**DALLAS FORT WORTH
INTERNATIONAL AIRPORT**

ADDENDUM NO. 02

RENTAL CAR CENTER SERVICE SITE HAIL CANOPIES

CONTRACT NO. 9500711

Alternate Foundation Detail Examples – Spread Footings

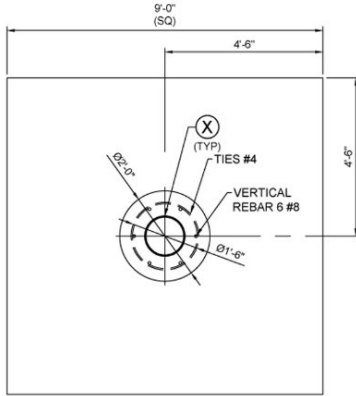
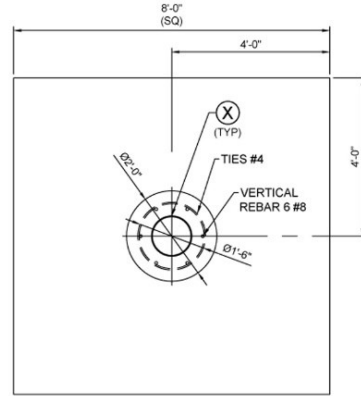
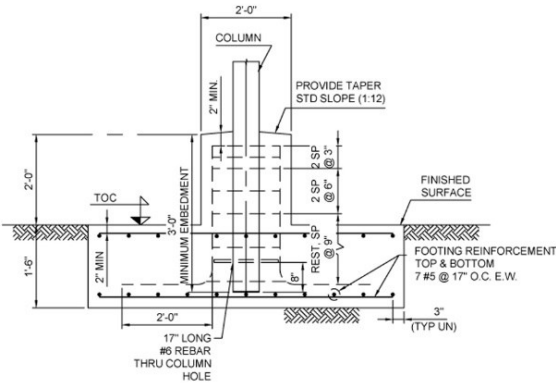
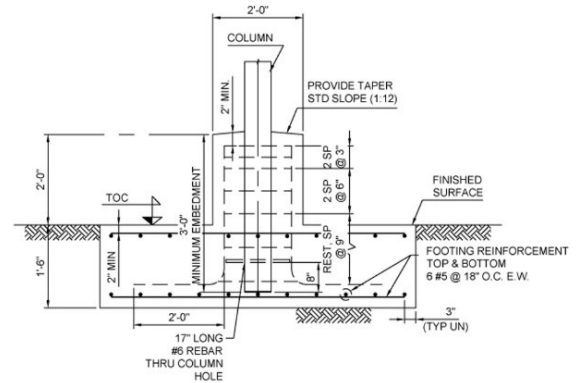
To be used only where a drilled pier footing is not feasible and/or cost prohibitive due to potential conflict with an existing underground utility.
